REGULATORY INFORMATION DISTRIBUTION SYSTEM (RIDS)

SUBJECT: Responds to ltr re violations noted in Insp Repts
 50-528/89-36, 50-529/89-36 & 50-530/89-36.

Subject: Palo Verde Nuclear Generating Station (PVNGS)
Units 1, 2, and 3
Docket No. STN 50-528 (License No. NPF-41)
STN 50-529 (License No. NPF-51)
STN 50-530 (License No. NPF-74)
Reply to Notice of Violation - 50-528/89-36-01, 530/89-36-03,
529/89-36-01, and 530/89-36-01
File: 89-070-026

Simplified FUEL POOL CLEANUP SYSTEM

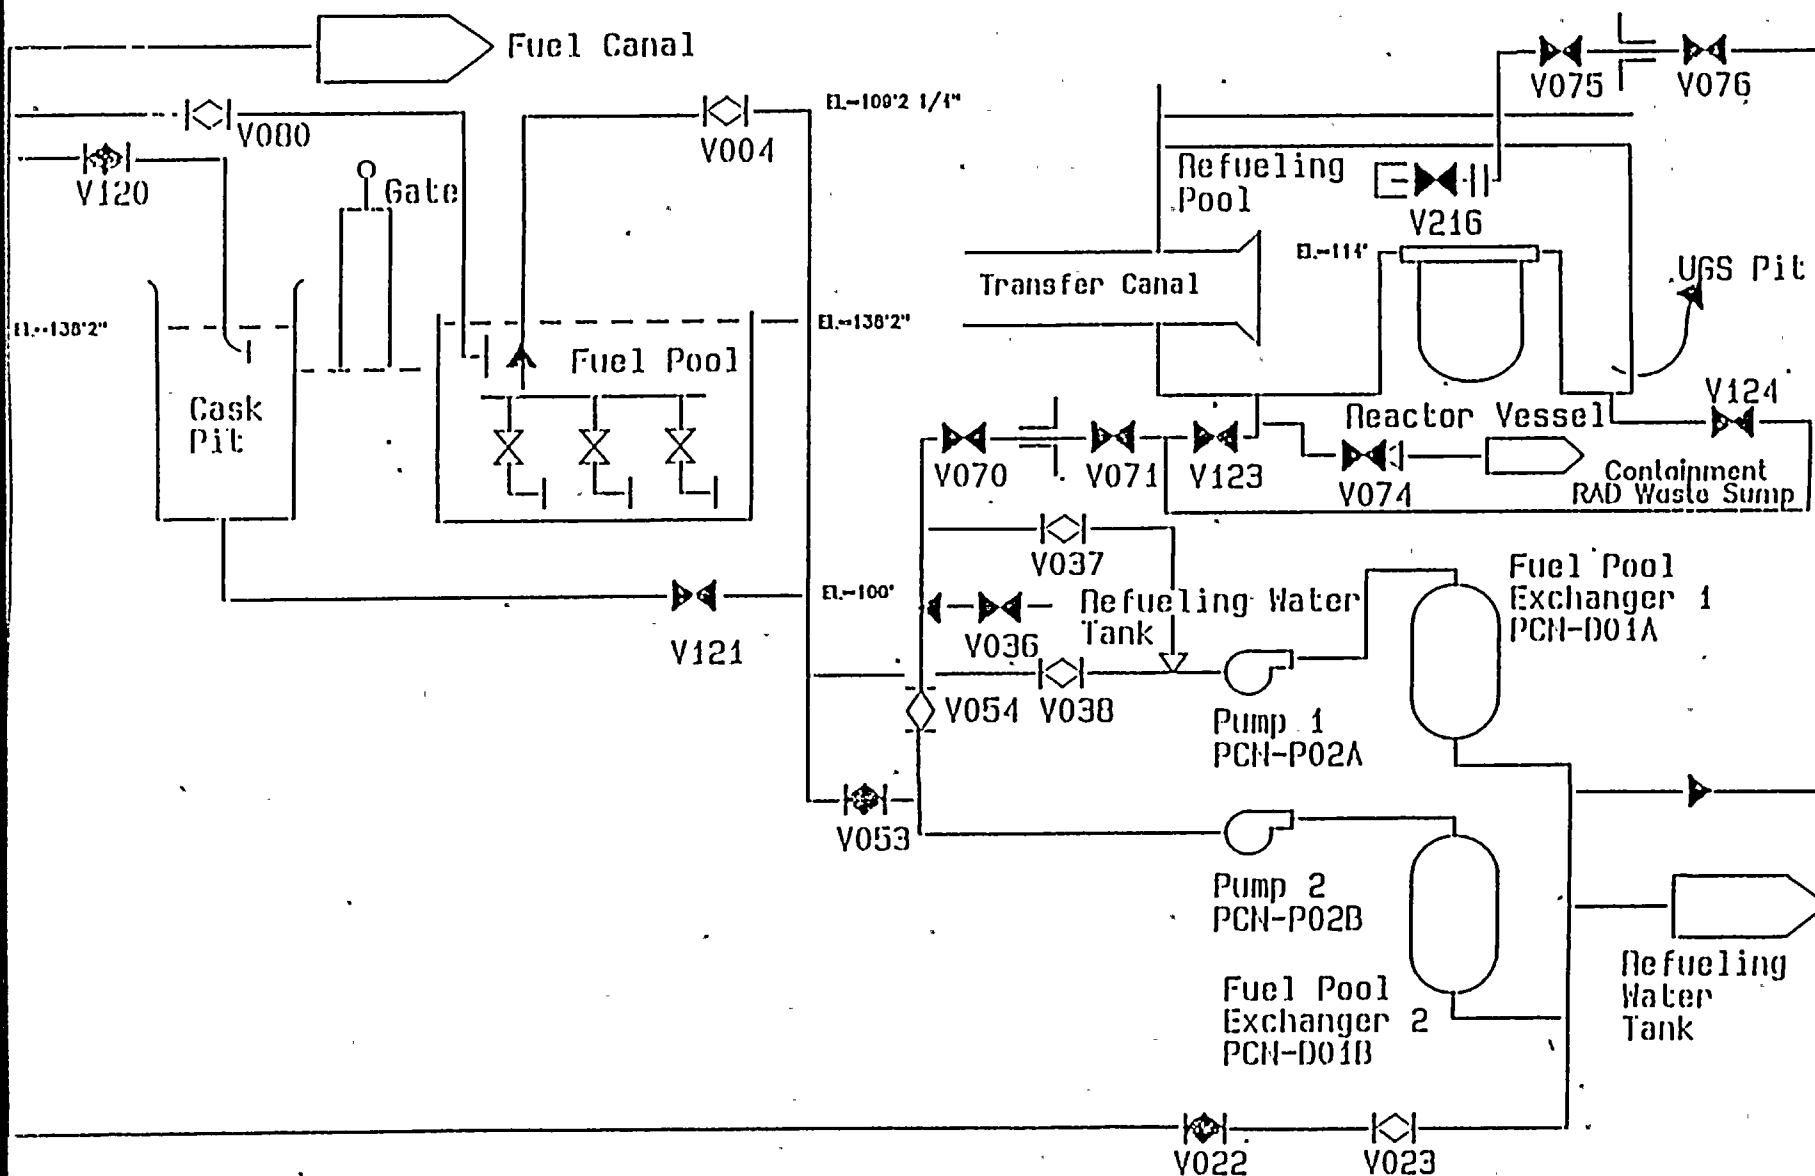
Contrary to the above, on August 2, 1989, in Unit 1 during a planned evolution, valve PCN-V004, which encompassed the desired flow path, was not verified shut, thereby causing an unintended flow path which resulted in lowering Spent Fuel Pool level to less than the Technical Specification minimum required level.

The flow path specified by the temporary valve lineup was from the Cask Pit through valves V121 (the controlling valve), V053, V054, V070, V071 and V123 into the Refueling Pool Transfer Canal (see attached simplified drawing). Note that valve V004 was not a part of the temporary lineup or the intended flow path.

Each valve within the planned flow path for the temporary valve lineup for the gravity drain evolution was actually verified in its correct position as required by the Night Order issued on May 25, 1989. As noted, valve V004 was intentionally not part of the valve lineup nor was it part of the desired flow path and was intentionally left open. Accordingly, the event did not involve violation of the Night Order which is the basis for the Notice of Violation. Nevertheless, the event should not have occurred and is of concern to APS management. The contributory causes to this event have been determined to be:

1. The failure by the Shift Supervisor to adequately consider all the potential gravity drain paths when planning the temporary lineup, specifically, path V004 through V053.
2. The independent review by the Assistant Shift Supervisor also failed to identify valve V004 as a potential gravity drain path.
3. The failure by the operators to monitor Spent Fuel Pool level

Based on the above, APS has determined the root cause of this event was that management did not ensure adequate proceduralized guidance in place to control the multiple flow paths in the Spent Fuel Pool Cleanup System for various types of evolutions.
